MIDLAND PLANT UNITS 1 AND 2
RESPONSE TO NRC STAFF REVIEW CONCERNS
FOR UNDERPINNING OF THE AUXILIARY BUILDING

JUNE 3, 1982

Midland Plant Units 1 and 2
Response to NRC Review Concerns
for Auxiliary Building Underpinning

| Figure 2-1 |

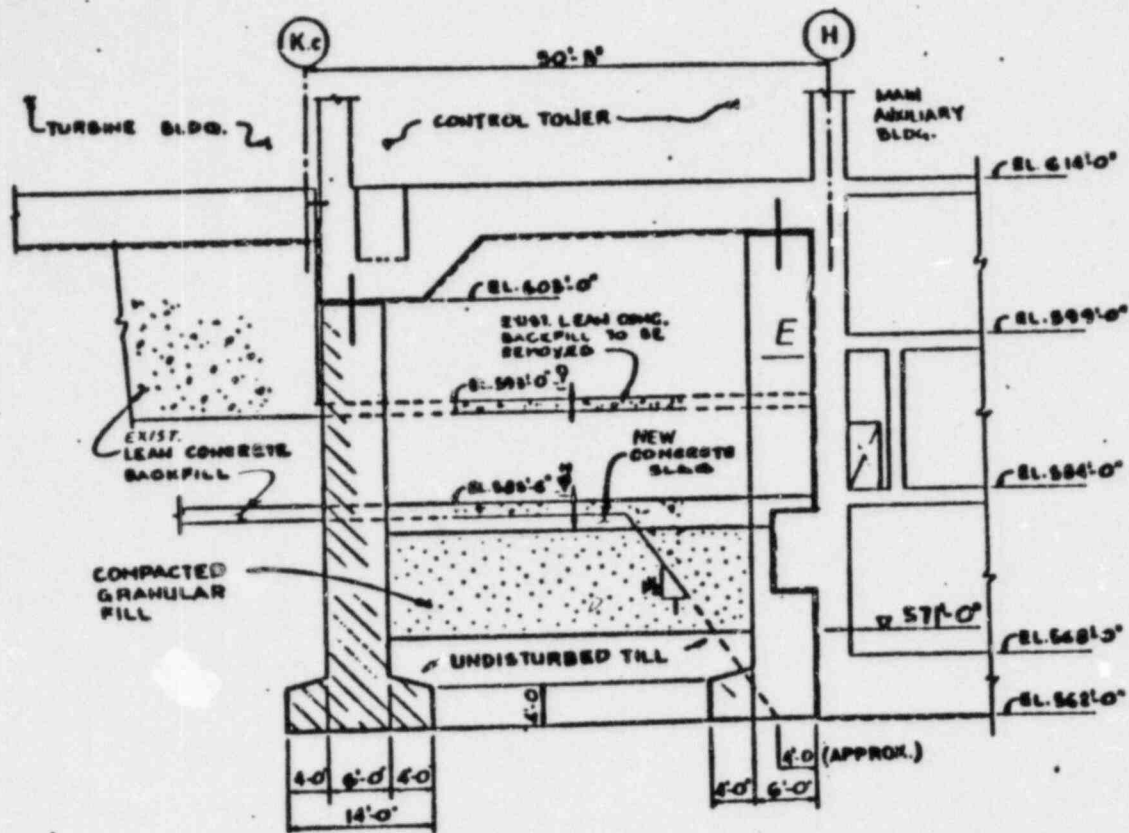
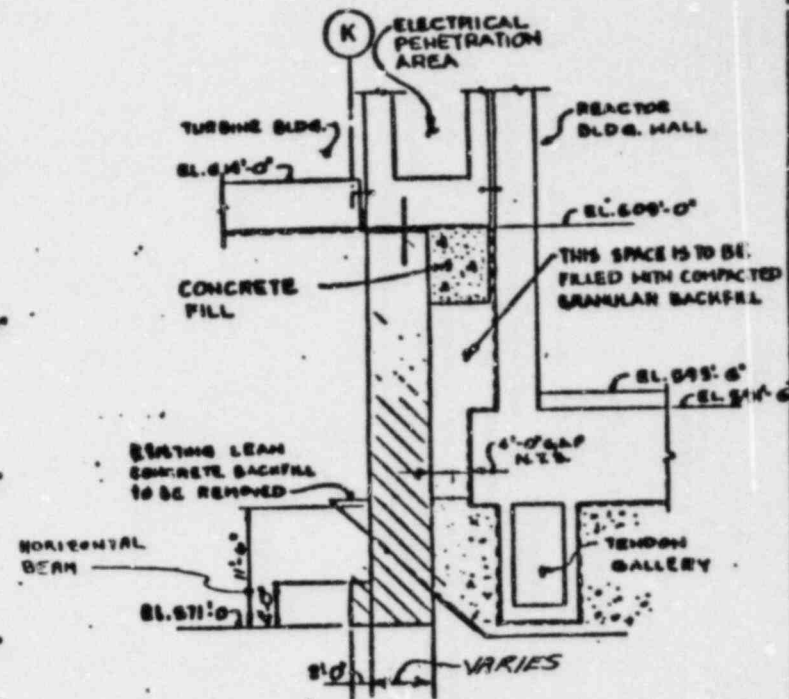
The design concepts of the underpinning walls below the electrical penetration areas (EPAs) and the control tower have been described in Reference 5. Figures 2-1 and 2-2 show the underpinning wall and reinforcing detail and Figure 2-3 shows typical connection details with the EPA and control tower

FIGURE 2-5

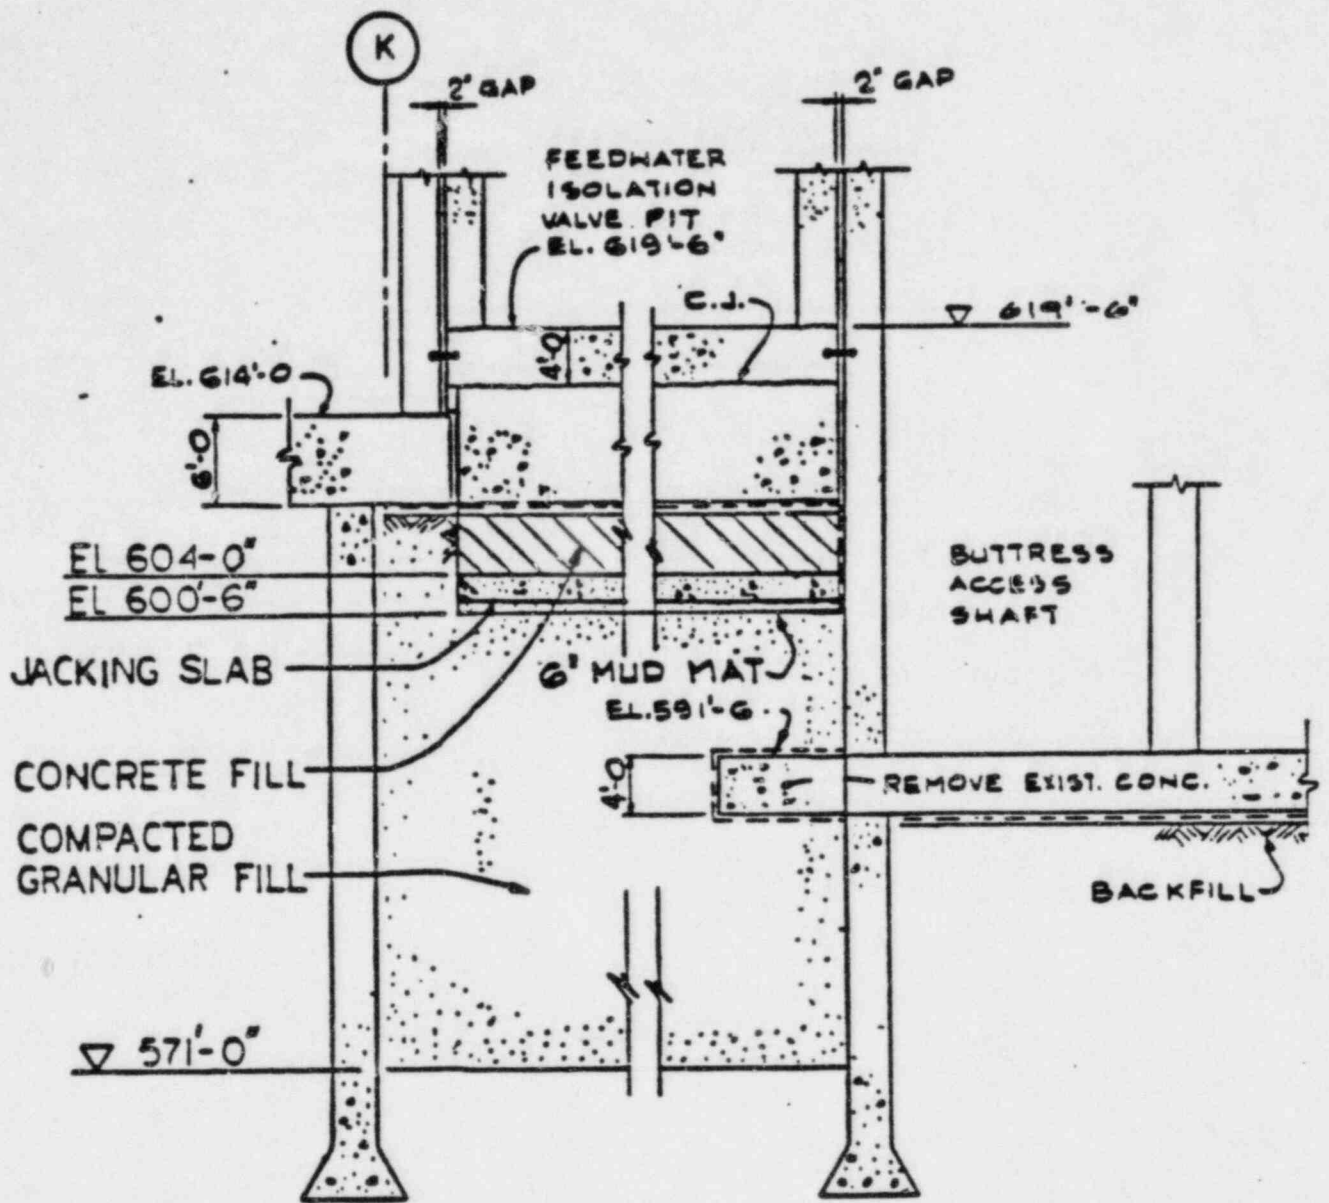
The analysis concept for the FIVP foundation has been described in Reference 5. The support detail is shown in Figure 2-5; Table 2-3 shows the soil pressures under the foundation and rebar details for the 3'-0" thick jacking slab.

Figure 2-6

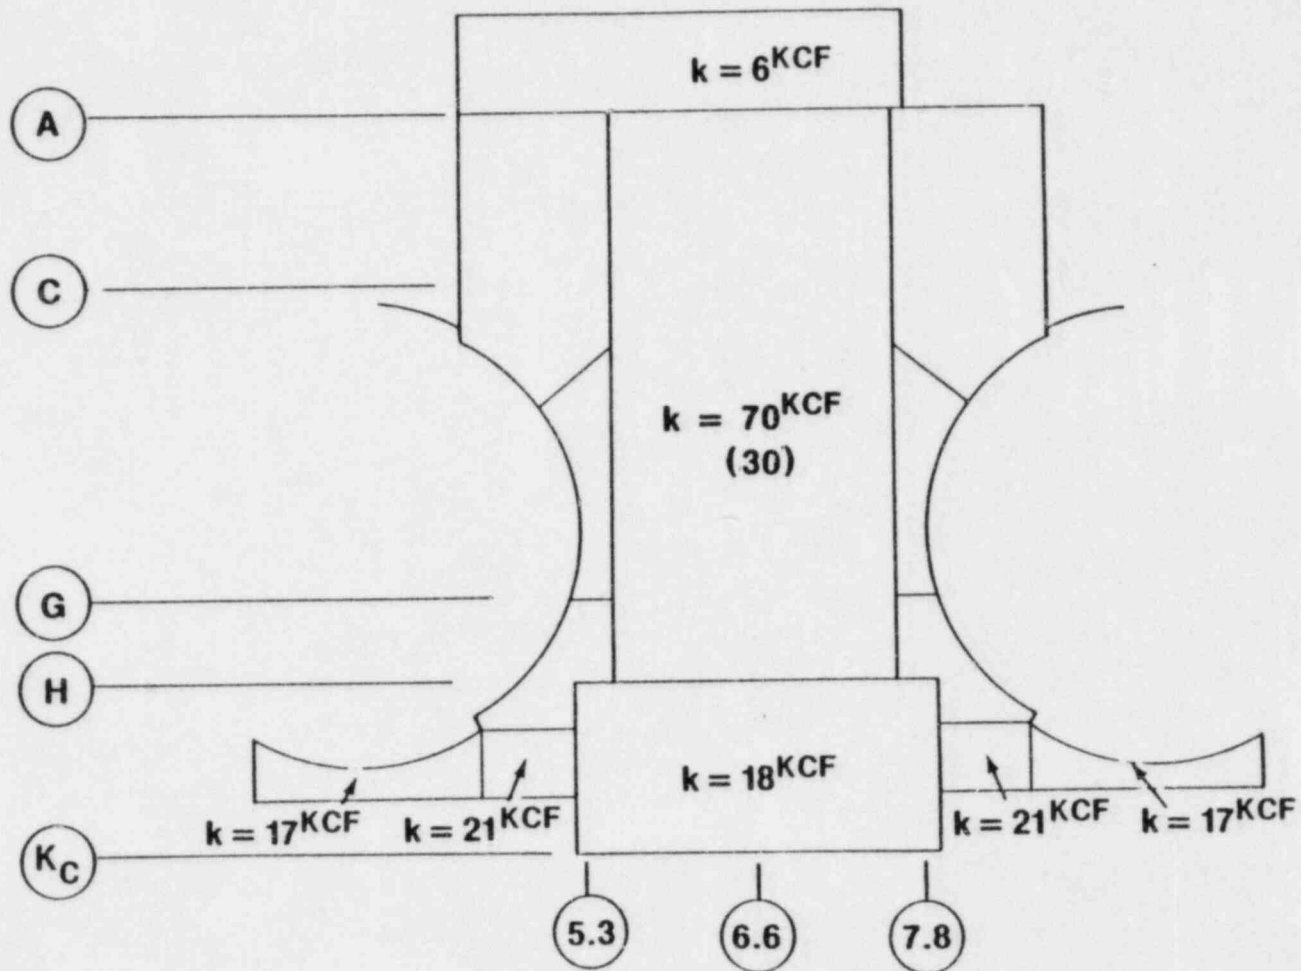
The soil springs are based on the values of soil moduli as shown in Figure 2-6.

Figure 2-7

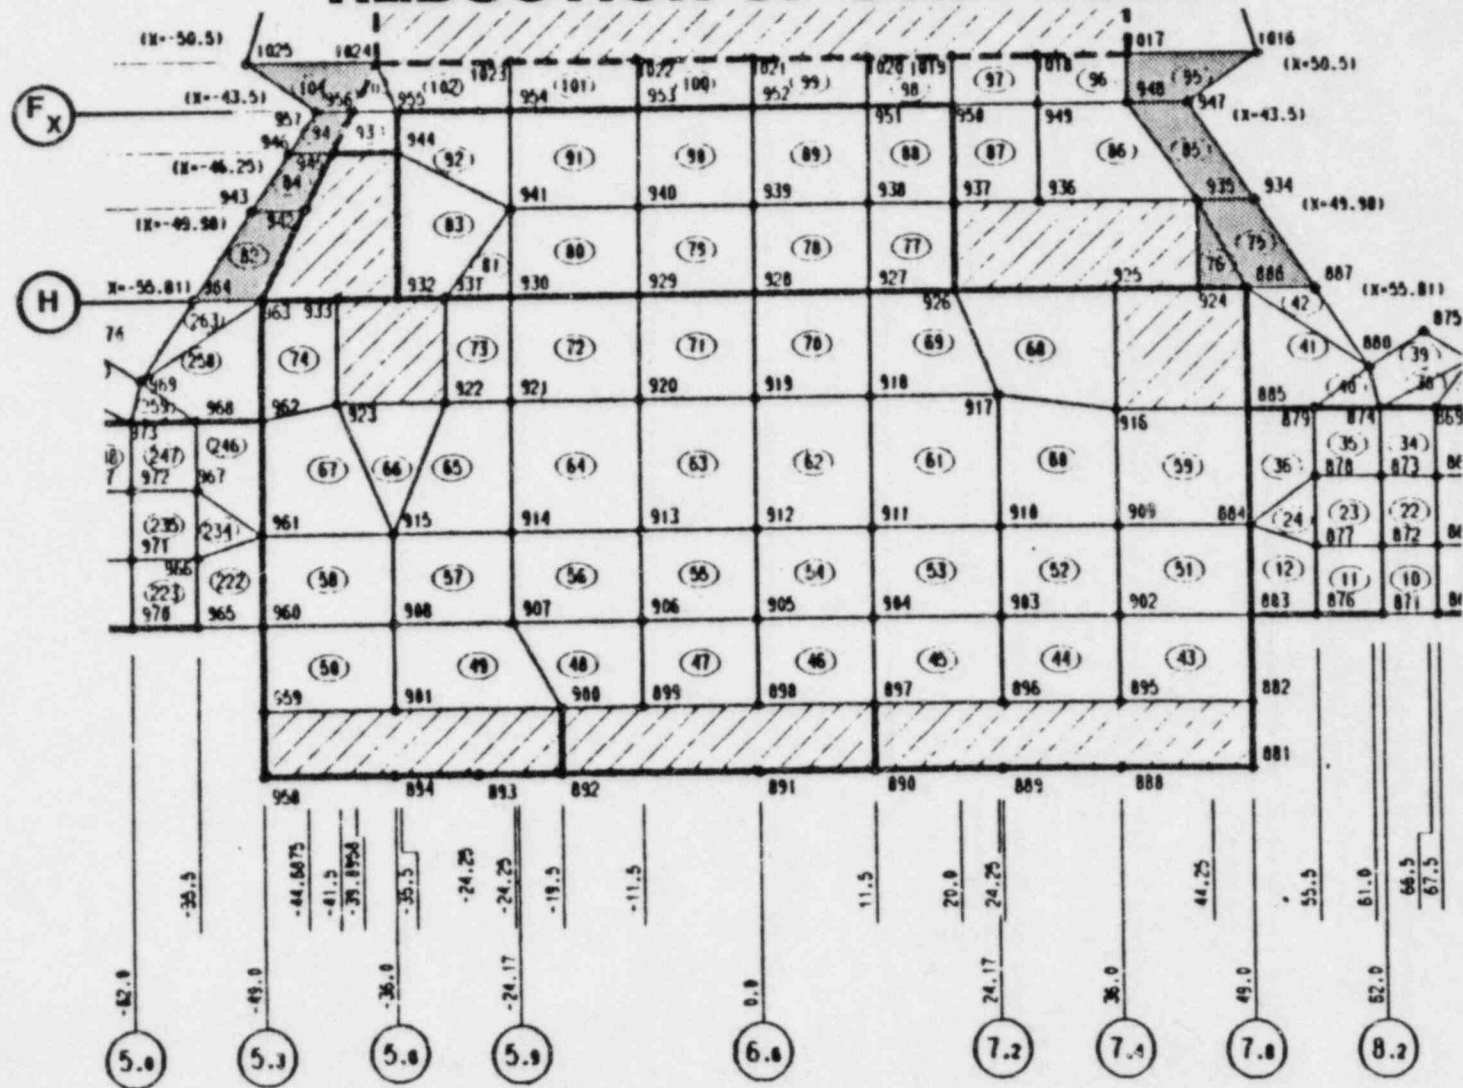
This reduced stiffness decreased the stresses on these elements; however, the average stress on a total length of the slab as shown in Figure 2-7 increased by a small amount compared to the uncracked analysis (with soil modulus $K = 30$ kcf under the main auxiliary building).

Figure 2-11
PARAMETRIC STUDY I

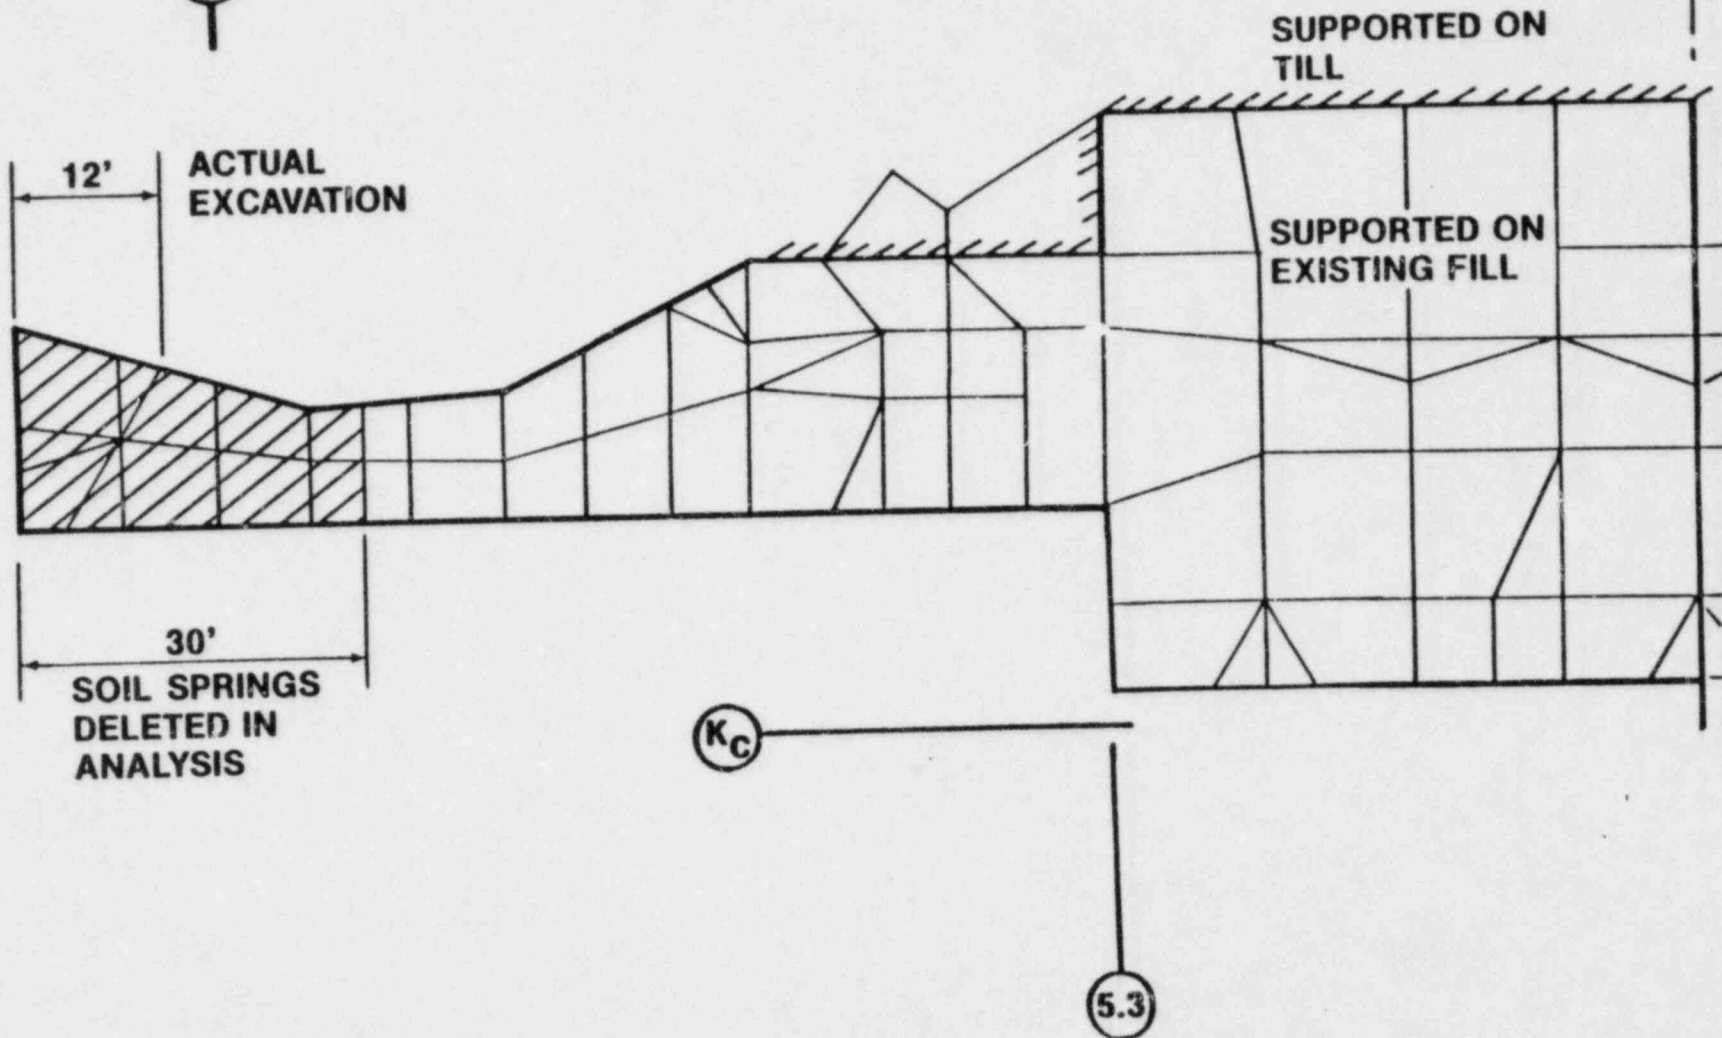
In Stage 1 of construction, the soil at the two extremes of the EPAs is removed (Figure 2-11). To satisfy staff concerns, the width of soil removal is assumed to be 30 feet, compared to 20 feet assumed for Stage 1 in the previous analysis with $K = 30$ kcf under the main auxiliary building.

Figure 2-12

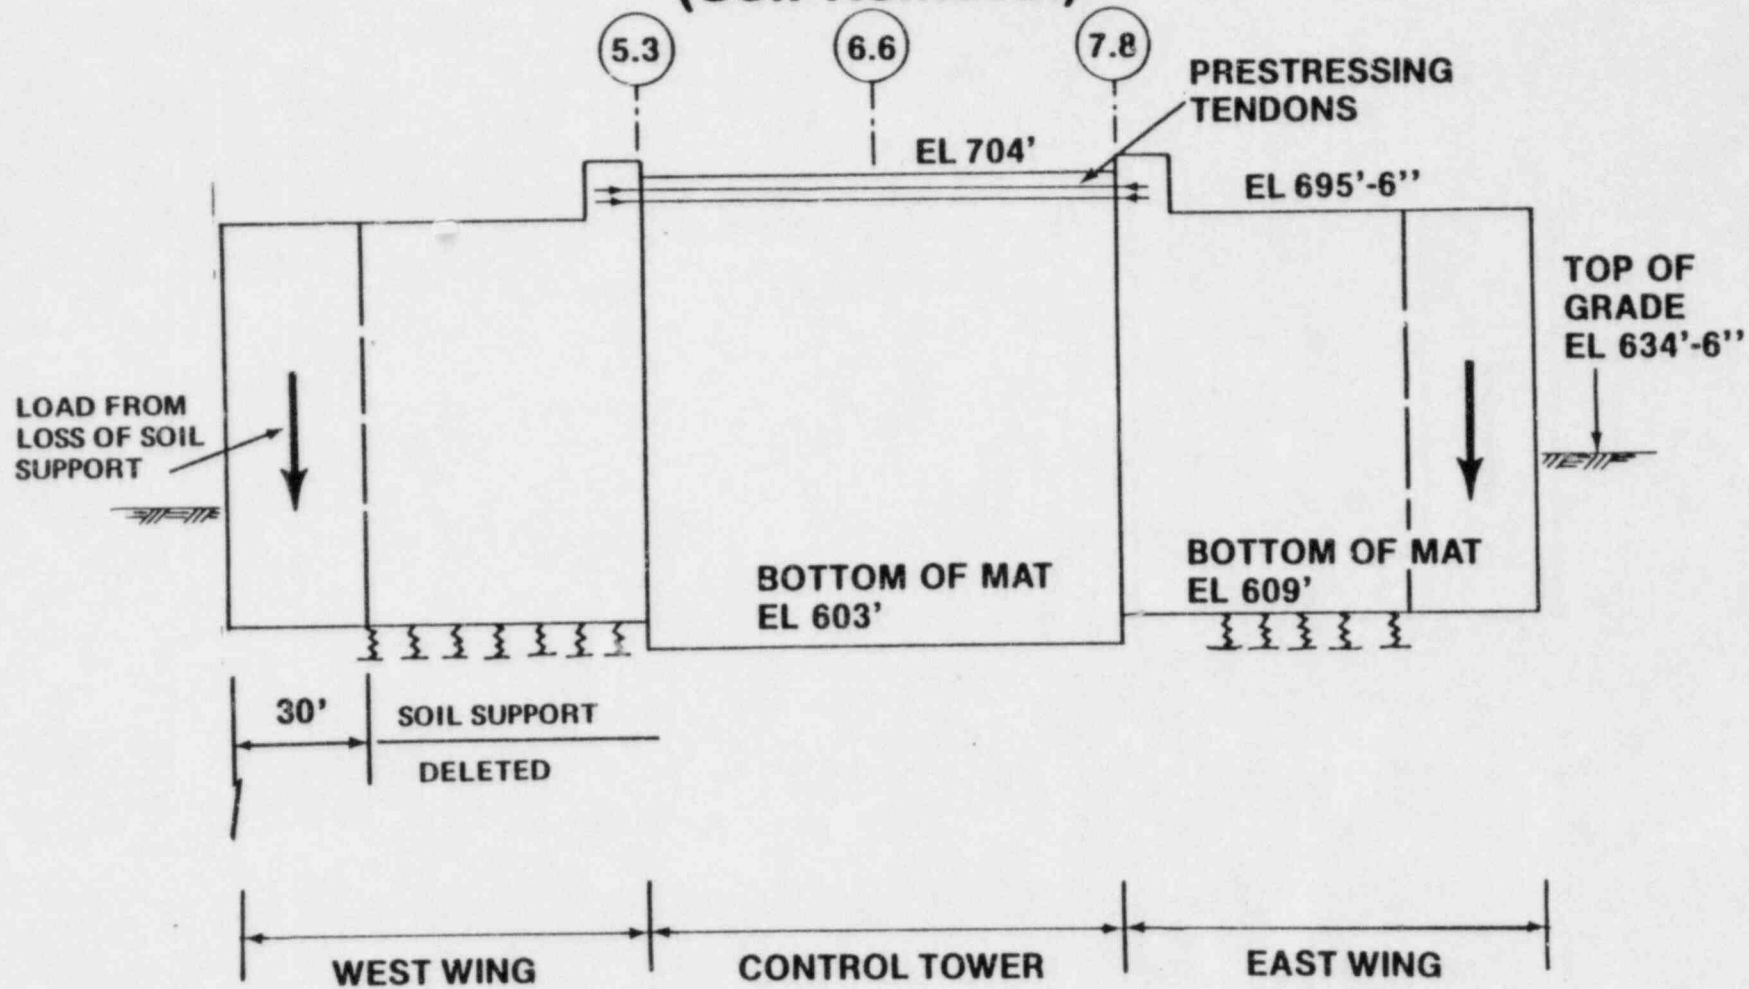
construction, the effect of soil removal has been simulated by applying a downward load at the ends of a weightless structure as shown in Figure 2-12. The magnitude of this downward load is equal to the sum of the reactions of the springs removed.
